| Model: LCT for AD1-E              |  | Date: 15-Feb-98        | No: 1 |
| Modified Article: Timing Pulley   |  | Prepared by: K. Ugaeri |       |

## MB Correction

3.LCT UNIT 3 (A667)

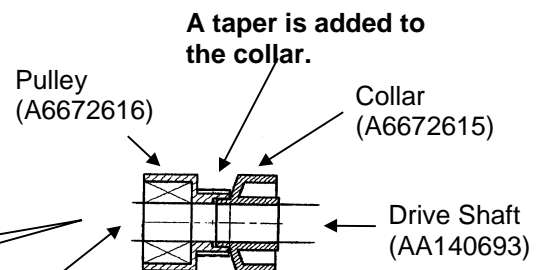
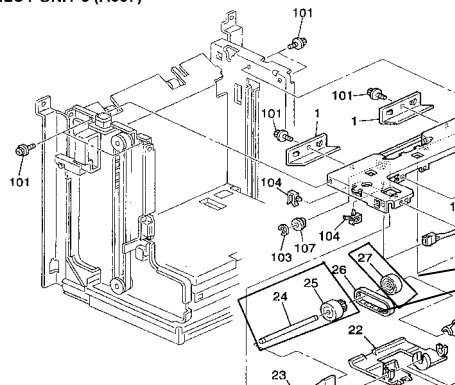
A.To reduce paper jams caused by dust between the timing pulley and the drive shaft :

The collar has been made so that a portion of it is inserted into the pulley.

| 1. AA140627(1) • AA140693(1) | Drive Shaft – Feed Roller  | } X/O | P 7-24 |
| 2. H5194713(1) • A6672615(1) | Timing Pulley Collar – 6x8 |       | P 7-27 |
| 3. H5194714(1) • A6672616(1) | Timing Pulley – 22Z        |       | P 7-25 |

5.LCT UNIT 5 (A667)

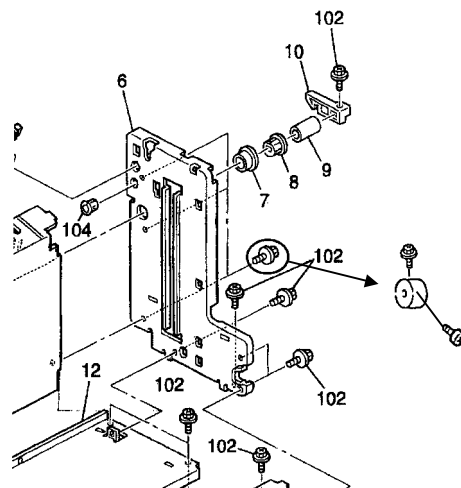
B.To reduce the noise from the relay roller :

| 1. AF020385(1) → AF020452(1) → Relay Roller       | } X/O | P11-16 |
| 2. A6672516(1) Fly Wheel (New)                    |       |        |
| 3. 03140060W(2) Philips Pan Head Screw-M4x6 (New) |       |        |

3.LCT UNIT 3 (A667)

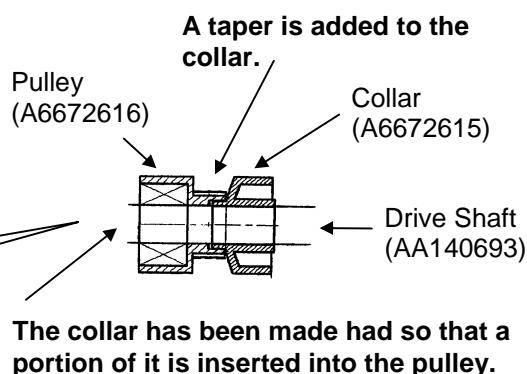
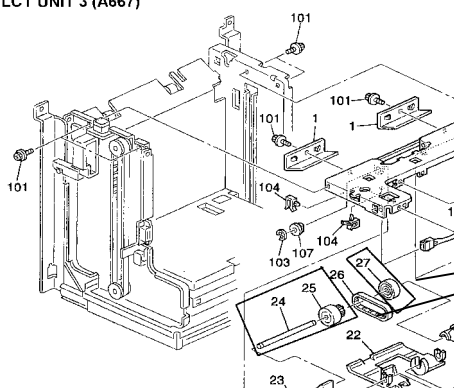
The illustration has changed as shown below.

A. To reduce paper jams caused by dust between the timing pulley and drive shaft :

| 1. AA140627(1) • AA140693(1) | Drive Shaft – Feed Roller  | } X/O | P 7-24 |
| 2. H5194713(1) • A6672615(1) | Timing Pulley Collar – 6x8 |       | P 7-27 |
| 3. H5194714(1) • A6672616(1) | Timing Pulley – 22Z        |       | P 7-25 |
